A d d e n d u m

Iowa Department of Transportation
Office of Contracts

B.O.	Proposal ID	Proposal Work Type	County	Project Number	Addendum
105	42-3720-613	PCC PAVEMENT WIDENING / PCC RESURFACING	HARDIN	STP-U-3720(613)--70-42	17MAR105.A01

TYPICAL SECTION - WASHINGTON AVENUE
 51' B-W/ 6" STANDARD CURB
 STA. 105+89.34 - STA. 109+50.00

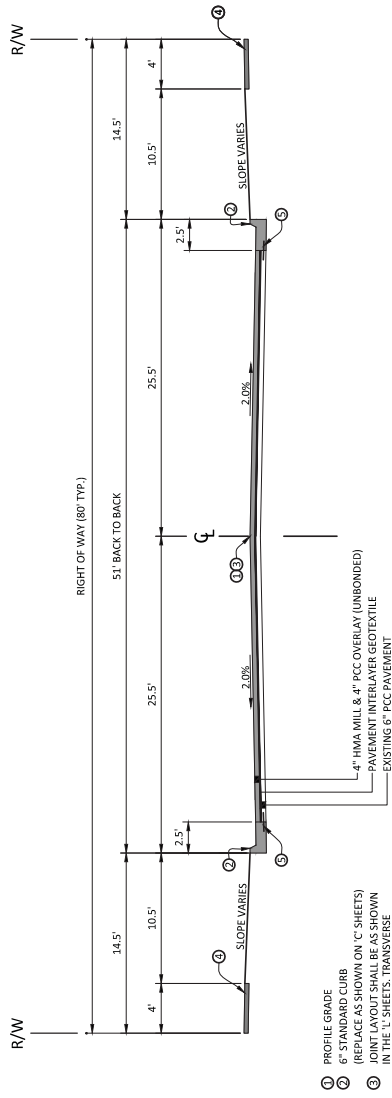
Replace Plan Sheet B.01 with the attached Plan Sheet B.01. Note 3 was changed to read, "Joint layout shall be as shown in the 'L' sheets. Transverse joints shall be 'C'".

Replace Plan Sheet B.02 with the attached Plan Sheet B.02. Note 3 was changed to read, "Joint layout shall be as shown in the 'L' sheets. Transverse joints shall be 'C'".

- ① PROFILE GRADE
- ② 6" STANDARD CURB
(REPLACE AS SHOWN ON 'C' SHEETS)
- ③ JOINT LAYOUT SHALL BE AS SHOWN
ON 'C' SHEETS. TRANSVERSE
JOINTS WILL BE 'C'
- ④ EXISTING SIDEWALK
- ⑤ BT-5 JOINT IN EXISTING PCC
PAVEMENT
